**PROPOSED MIDDELWATER CLASS B  
WASTE FACILITY**

**ADDENDUM TO DESIGN REPORT**

**REVISION 2**

**Ref. No.755-2022  
January 2026**

<b>SCALE</b>	1:2000	<b>SCALE</b>	A0
<b>JOB NUMBER</b>	755-2022	<b>SHEET NO.</b>	1 OF 1
<b>DRAWING NO.</b>	755 - 2022 - 013 - REV-B

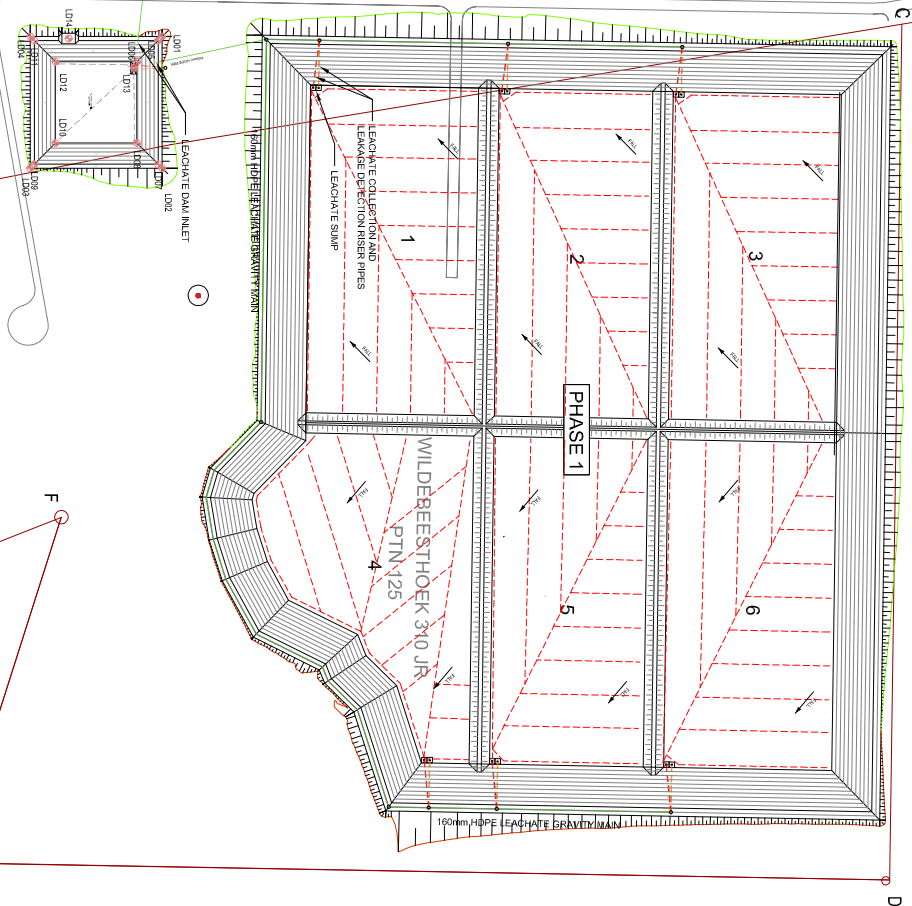
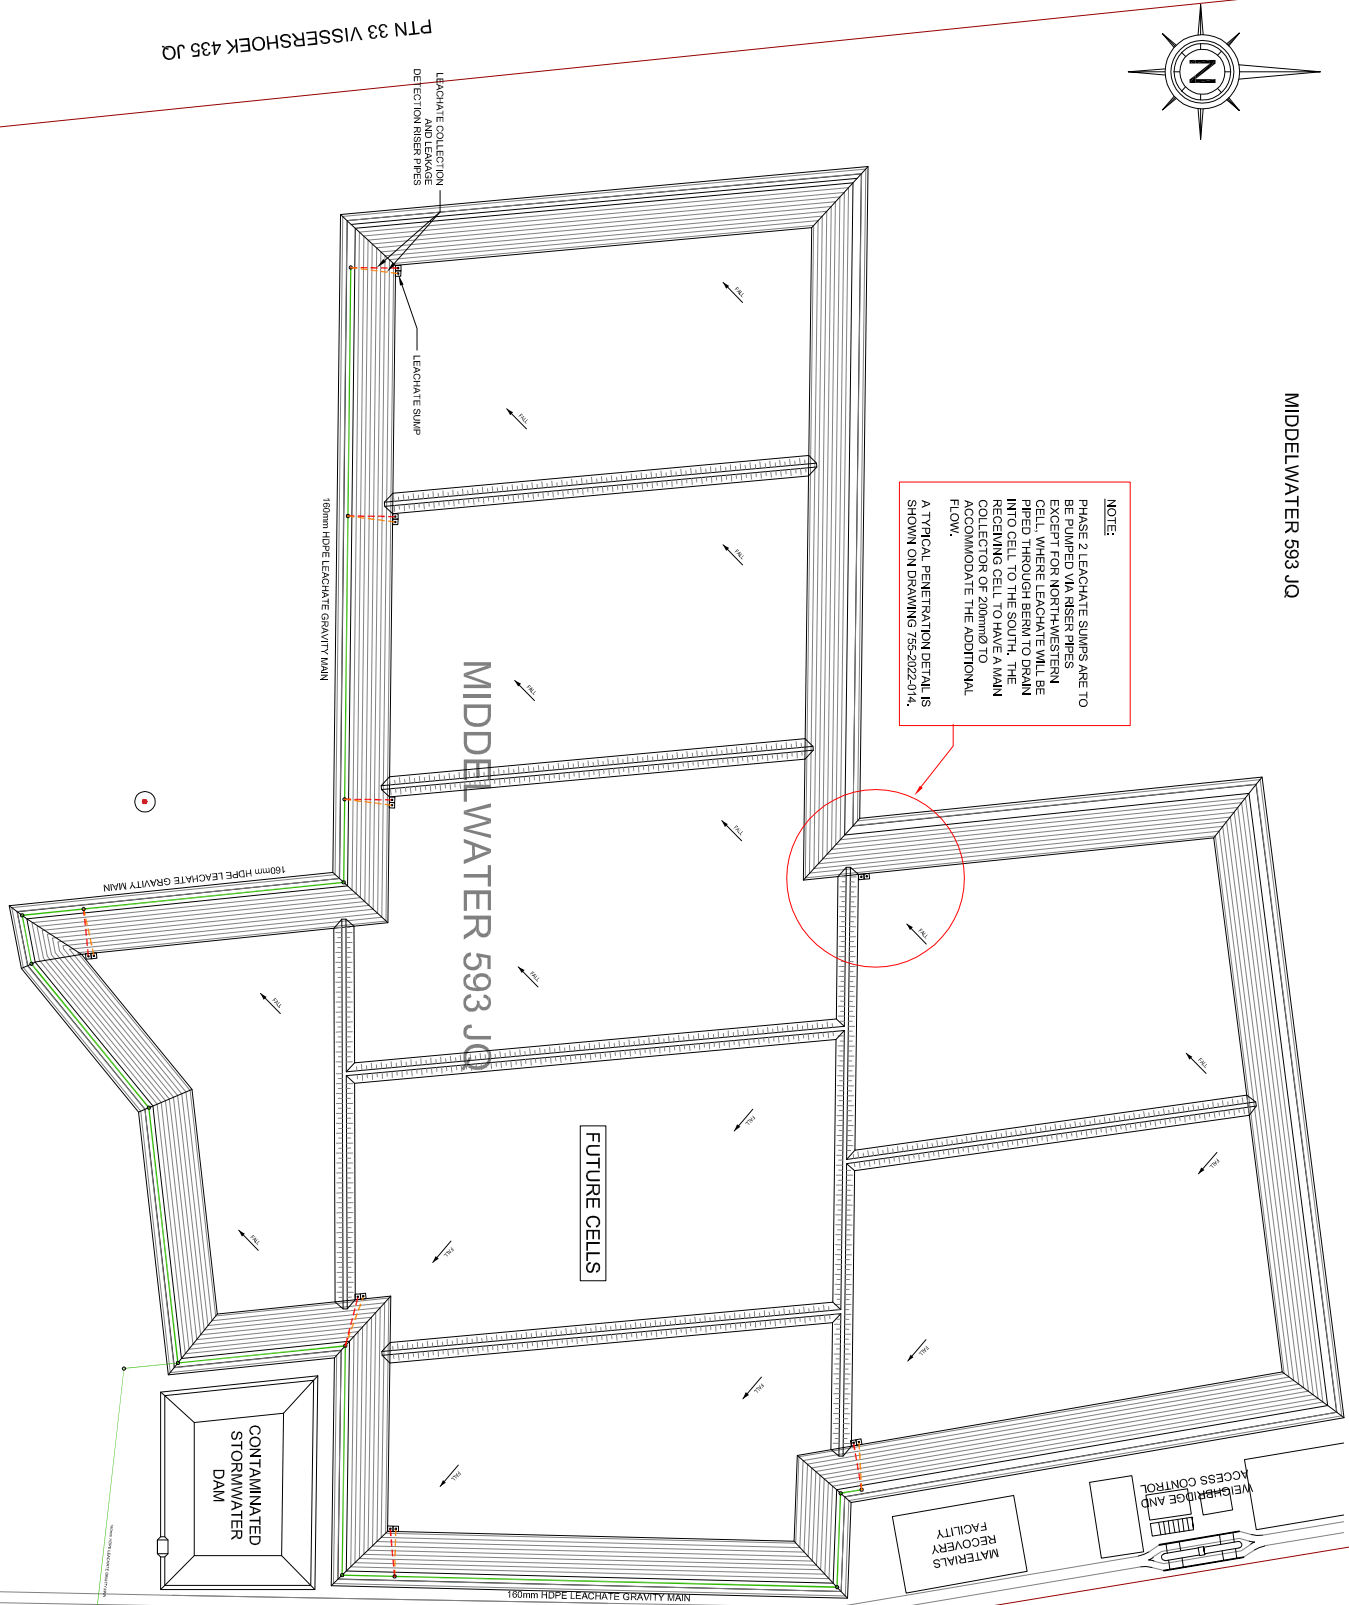
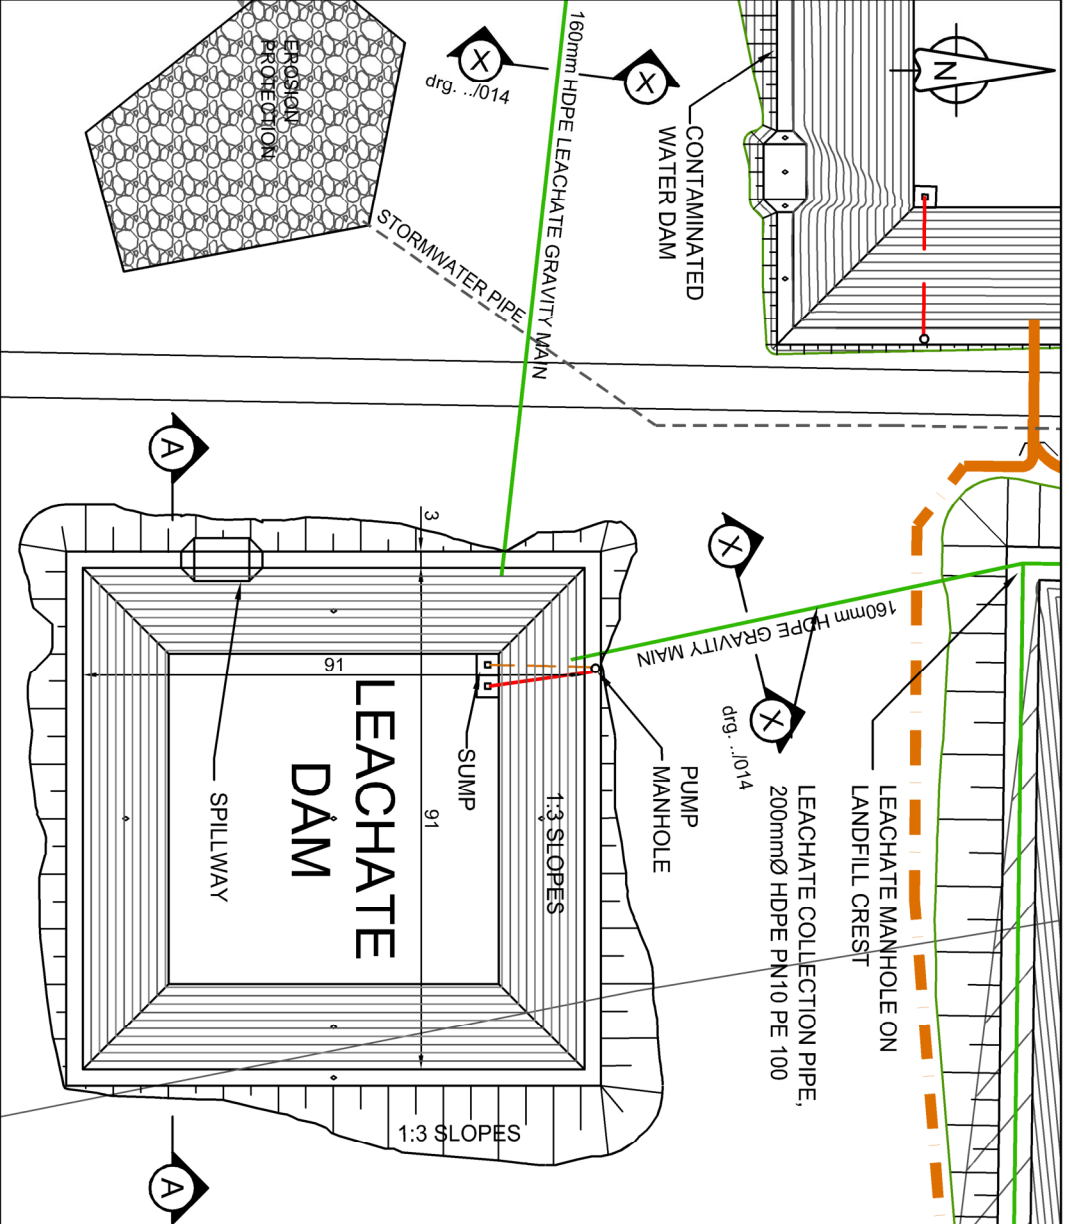
2.4	<p>Middelwater Resource Facility (Pty) Ltd must provide a general layout arrangement drawing for the leachate collection system (LCS) and the underdrainage pipe collection system.</p> <ul style="list-style-type: none"> <li>• These drawings must clearly illustrate the alignment, component details, and connectivity of the systems.</li> <li>• The signed design drawing must be submitted to the Department for approval.</li> </ul>	Envitech	<p>Please see drawing no: ES755-2022-007 rev B and -013 rev B for LC and LD drainage pipes layout.</p> <p><u>Connectivity</u> LD and LC perforated pipe fittings shown on drawing 755-2022-014. CQA Report details solid HDPE pipe specifications and fusion welding.</p> <p>Pipe penetration detail of crest penetration shown on drawing 755-2022-014 (cells) and -017 sheet 2 (for Leachate dam). Also shown on -017 is the concrete - encased penetration instance.</p> <p>See Design Report drawing no. 755-2022-009 rev B showing decant from cells is via a riser pipe and pumped to a gravity main, which is HDPE, electro-fusion welded. The cells are not inter-connected. The design principle followed is that the cells' leachate systems are not interconnected.</p>

- The demonstration must be included in the amended documents and submitted to the Department.
- 2.4 Middelwater Resource Facility (Pty) Ltd must provide a general layout arrangement drawing for the leachate collection system (LCS) and the underdrainage pipe collection system.

- These drawings must clearly illustrate the alignment, component details, and connectivity of the systems.
  - The signed design drawing must be submitted to the Department for approval.

**NOTE:**  
 PHASE 2 LEACHATE SUMPS ARE TO BE PROVIDED FOR ALL FUTURE CELLS EXCEPT FOR NORTHWESTERN CELL, WHERE LEACHATE WILL BE PIPED THROUGH BEAM TO DRAIN INTO CELL TO THE SOUTH, THE RECEIVING CELL TO HAVE A MAIN COLLECTOR OF 200mm Ø TO ALLOW FOR FUTURE ADDITIONAL FLOW.  
 A TYPICAL PENETRATION DETAIL IS SHOWN ON DRAWING 755-2022-014.
